To: Potential Bidders
GS #111-077 – IHL Parking Lots and Streets Repairs

REFERENCE: Addendum #2
GS #111-077 – IHL Parking Lots and Streets Repairs
Jackson, MS

This Addendum forms a part of the Contract Documents and modifies the original Bidding Documents as noted below. Acknowledge receipt of this Addendum in the Bid Documents. The following changes, corrections, or interpretation to the plans, specifications, and/or contract documents are to be incorporated into the Issued Construction Documents of the above project:

C112
ENLARGED DEMOLITION
PLAN - PHASE 2

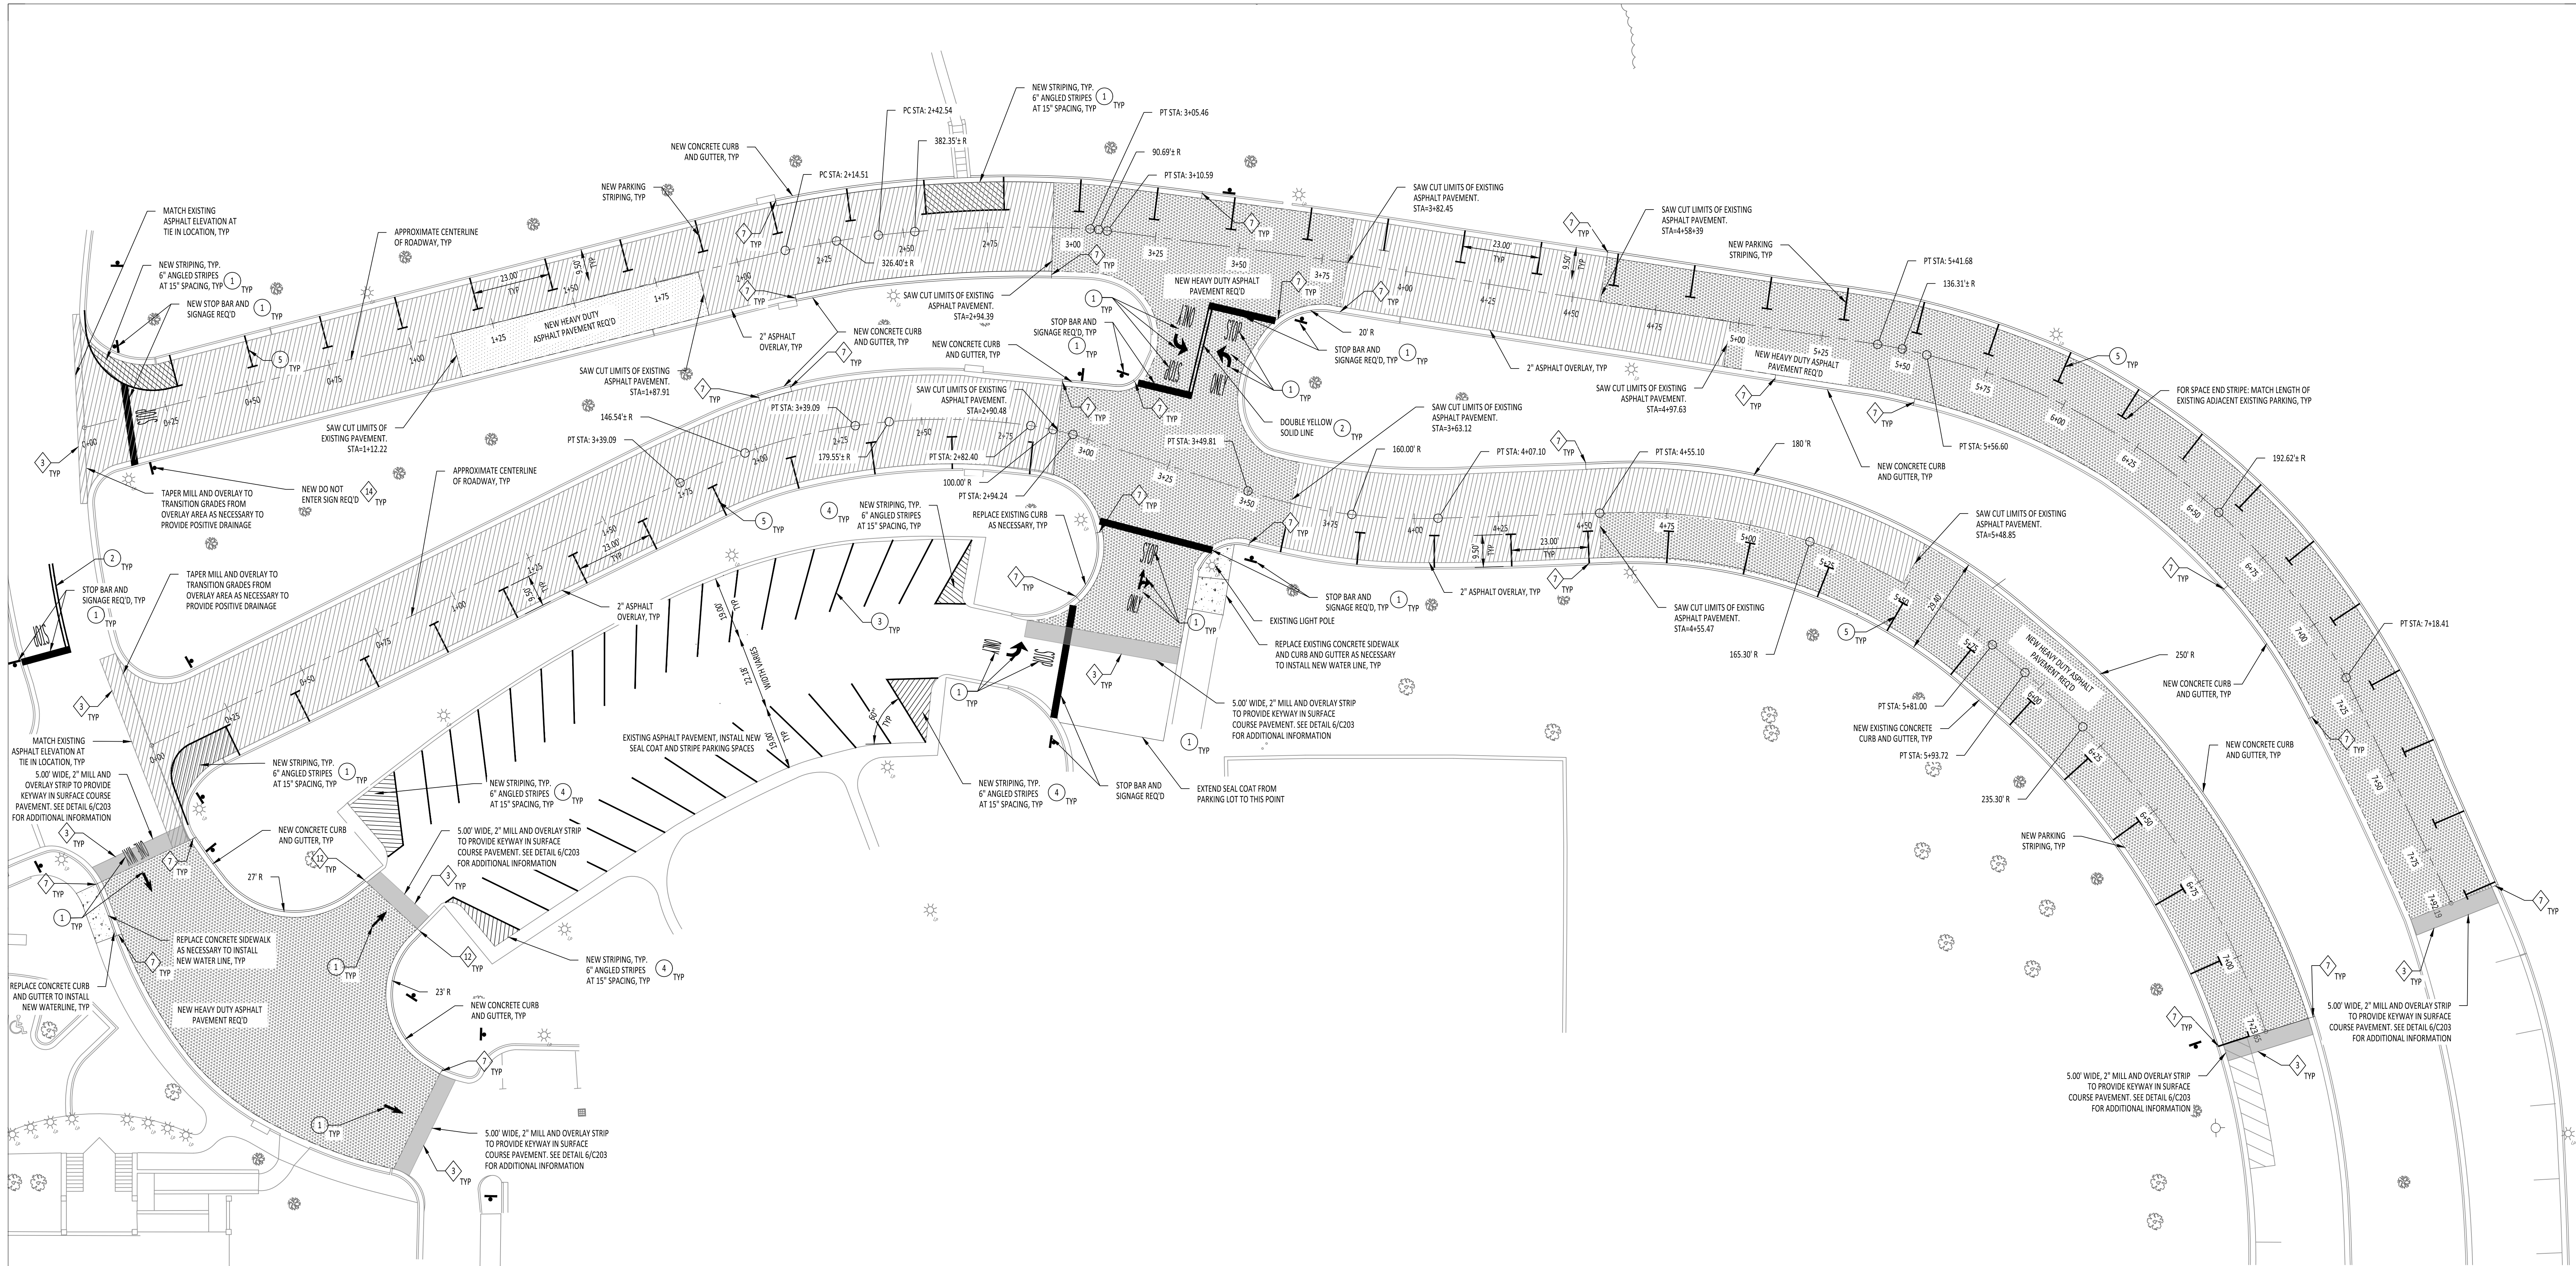
Change: | Revised Sheet C112
Revised sheet. |

C121
ENLARGED SITE PLAN -
PHASE 1

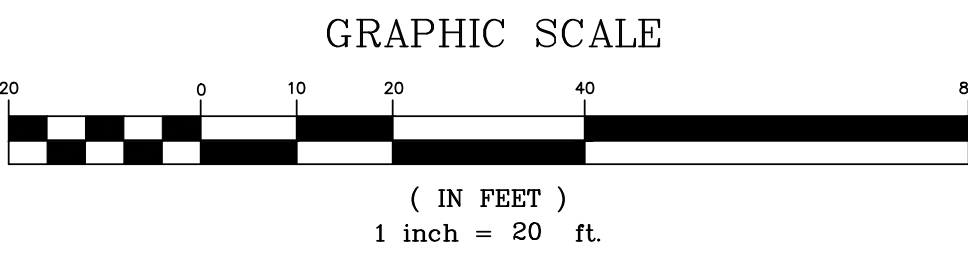
Change: Revised Sheet.
